# Access Compliance Report

## Public Rights-of-Way

### (Curb Ramps)

Intersection ID: 51491	Main Street: N_TRYON_ST	Cross Street: INSTITUTE_CR	Location: W
ADA ID: 8A68359959FE	Ramp Type: Perp	Initial Pass/Fail: Fail	Overall Compliance: No
		Severity Score: 10

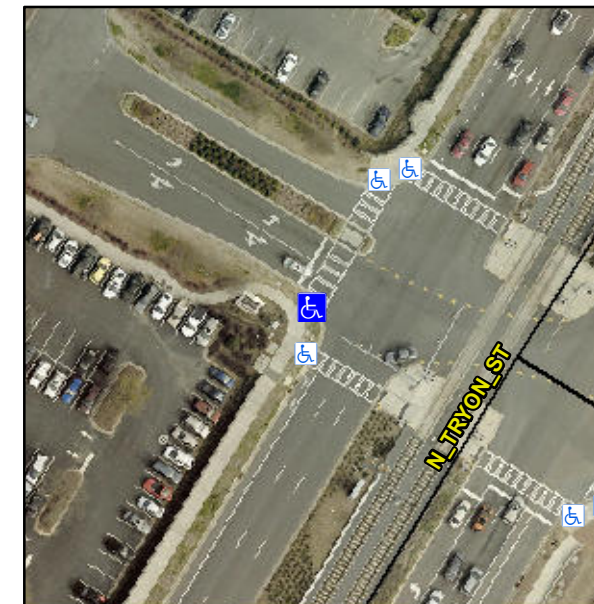
**Not Found, R304.5.1, R304.5.3**

Compliance	Description	Data	Compliance	Description	Data
N/A	Ramp Length (in)	105.0	Yes	Ramp Slope (%)	6.2
No	Ramp Width (in)	47.0	No	Ramp XSlope (%)	3.3
N/A	Flare Type LT	N/A	N/A	Flare Type RT	N/A
N/A	Flare Slope LT (%)	N/A	N/A	Flare Slope RT (%)	N/A
N/A	Flare Traversable LT?	N/A	N/A	Flare Traversable RT?	N/A
N/A	Landing Length (in)	N/A	N/A	DWS Provided?	N/A
N/A	Landing Width (in)	N/A	N/A	DWS Contrast?	N/A
N/A	Landing Slope (%)	N/A	N/A	DWS Length (in)	N/A
N/A	Landing X Slope (%)	N/A	N/A	DWS Full Width?	N/A
N/A	Landing Curb? (Y/N)	N/A	N/A	DWS Offset (in)	N/A
N/A	Shared Landing?	N/A			
N/A	Gutter Ponding?	N/A	N/A	Gutter Slope (%)	N/A
N/A	Gutter Lip Ht (in)	2.0	N/A	Gutter X Slope (%)	N/A
N/A	Painted X Walk1?	No	N/A	Painted X Walk2?	N/A
	X Walk 1 Direction	To NE		X Walk 2 Direction	N/A
N/A	X Walk 1 Width (in)	N/A	N/A	X Walk 2 Width (in)	N/A
	X Walk 1 Slope (%)	2.5		X Walk 2 Slope (%)	N/A
	X Walk 1 X Slope (%)	4.4		X Walk 2 X Slope (%)	N/A

**Remove & Replace Entire Ramp.**
